UNITED STATES
NUCLEAR REGULATORY COMMISSION
WASHINGTON, D. C. 20555

FACILITIES: Shoreham Nuclear Power Station Unit No. 1, Limerick
Generating Station Units No. 1 and No. 2, William H. Zimmer
Nuclear Power Station, Unit 1, Bailly Generation Station
Nuclear No. 1, LaSalle County Station Units No. 1 and No. 2,
Susquehanna Steam Electric Station Units No. 1 and No. 2,
WPPSS Nuclear Project No. 2, Nine Mile Point Nuclear
Station Unit No. 2.

SUBJECT: SUMMARY OF MEETINGS HELD ON DECEMBER 2, 1976 TO DISCUSS
MARK II CONTAINMENT STRUCTURAL DESIGN AND POOL DYNAMIC
LOADS SUPPORTING PROGRAM

Fig. 4

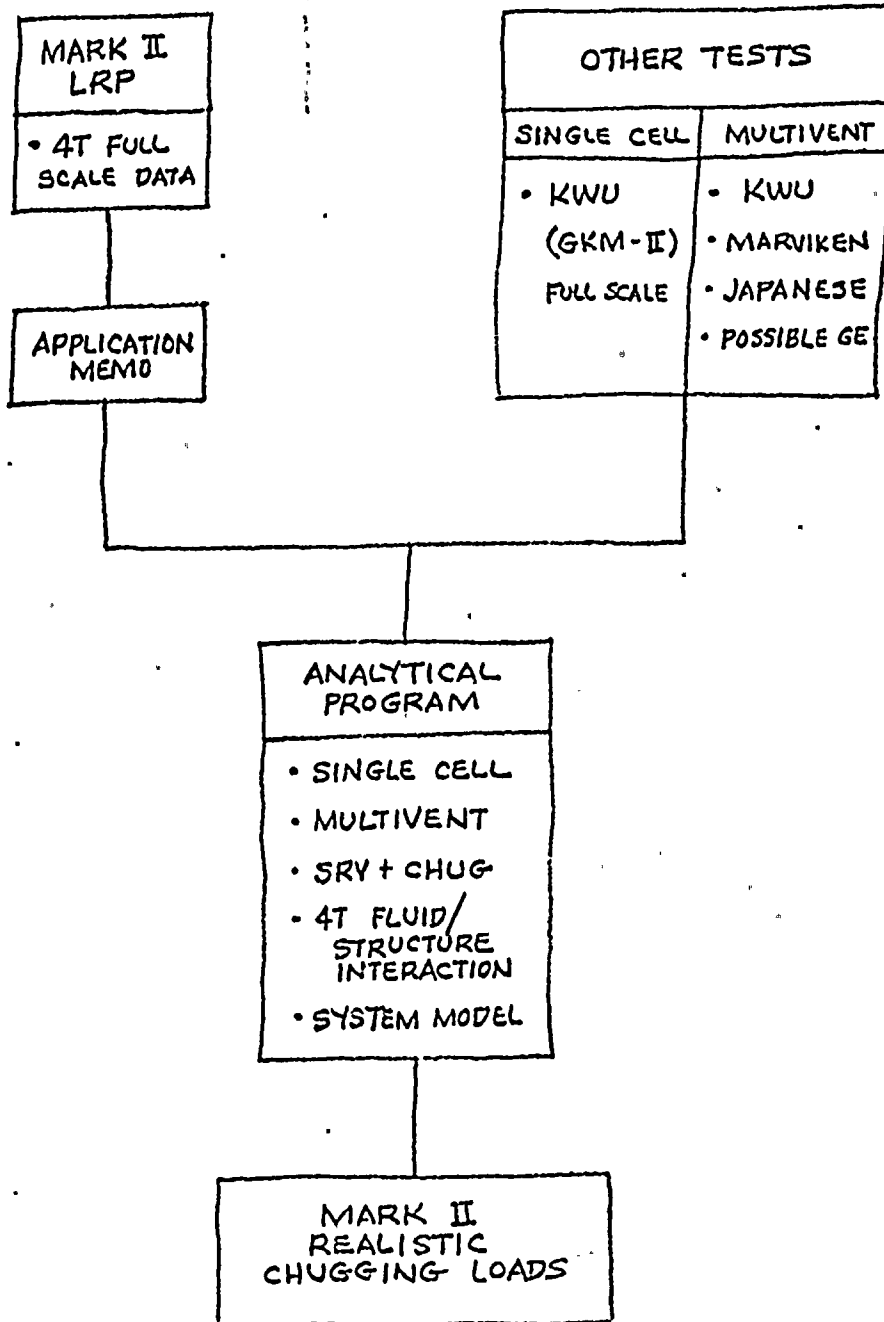
The program for defining the steam loads (chugging loads) developed by the Mark II owners consists of a parallel analytical and experimental approach. GE stated their analysis indicates that the single cell tests provide the bounding chugging load. Therefore, the objective of their chugging program will be to first confirm the conservatism of the single cell approach and then to develop a more realistic predictive method for individual plants (Fig. 4).

The overall chugging program technical strategy (the analytical and experimental program) is shown on Fig. 4. The analytical approach is to develop an analytical model from first principles and to compile and use all known experimental data to verify and refine the model. As a parallel effort GE is planning a multi vent test and has started the acquisition of equipment. However, they expect that their analytical approach will resolve the chugging problem and they do not expect to have to run the multi vent tests. The decision on whether to proceed with the tests will be made in January. The analytical program is a Mark I and Mark II owners jointly funded program. The current status of the program is shown in Fig. 5.
